**H.Y. ENGINEERING FILE: 174762**  
**PORT COQUITLAM PROJECT: SUB00169**

**RE: PROPOSED SINGLE-FAMILY SUBDIVISION LOCATED AT 1160 VICTORIA DRIVE, PORT COQUITLAM, BC**

**PROPOSED REZONING AND 26-LOT SUBDIVISION LOCATED AT 1160 VICTORIA DRIVE, PORT COQUITLAM, BC**

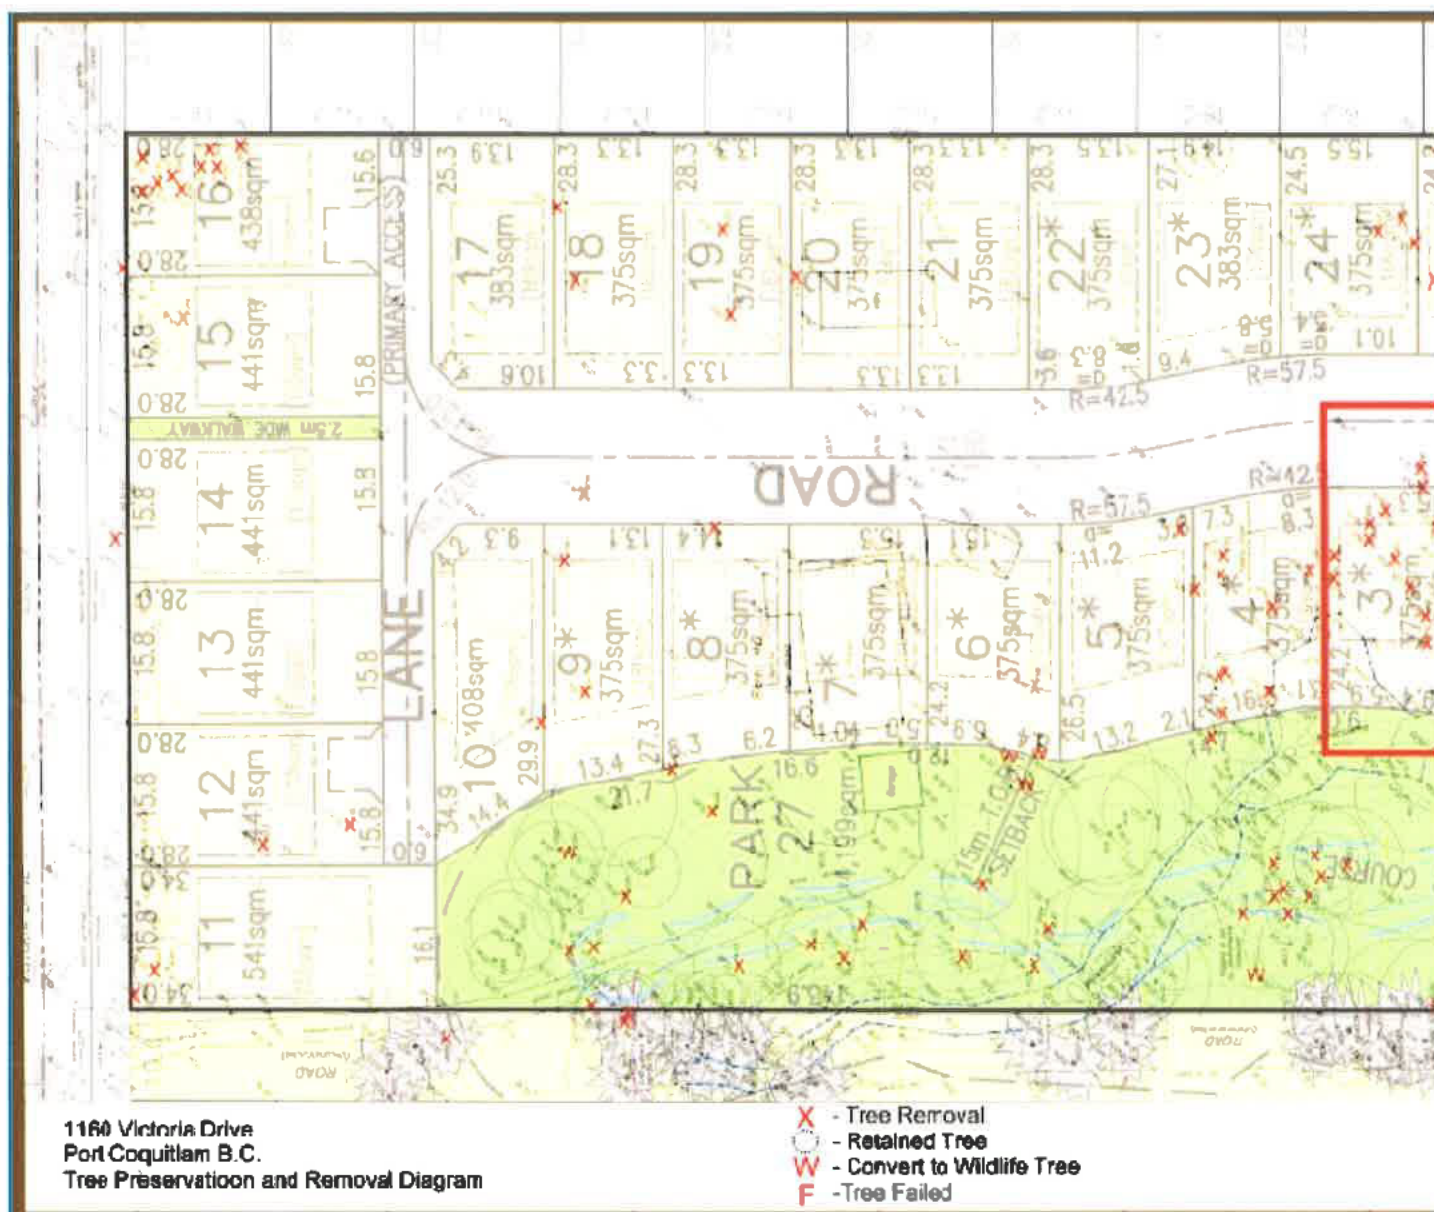
I do have one more question: will the current stand of Cottonwood trees in the south west corner remain? (I hope so, but understand development exigencies.)

Are you referring to the trees in the red box on the image below? The project Arborist has recommended these trees to be removed due to various factors, including conflict with the proposed road, building footprint, or condition.
